August 15, 2025

Version 2

## Safety Recall: 2019–20 RDX Front Passenger’s Seat Belt Buckle Replacement

Supersedes 25-019 dated May 30, 2025 to revise the information highlighted in **yellow**.

**REPLACEMENT SERIAL NO. FIELD**

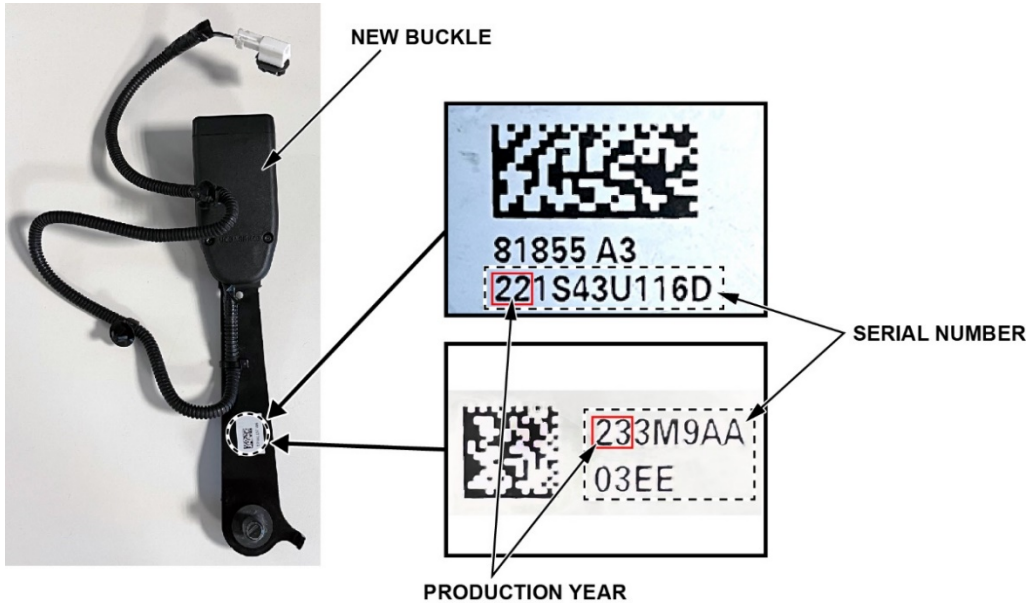
NOTE: To submit a warranty claim, the 11-digit serial number from the new buckle needs to be entered into the Replacement Serial Number field on the warranty claim form. Please have your technician provide the 11-digit serial number from the new seat belt buckle. **DO NOT enter the serial number of the buckle that was removed from the vehicle. The claim will not be approved.**
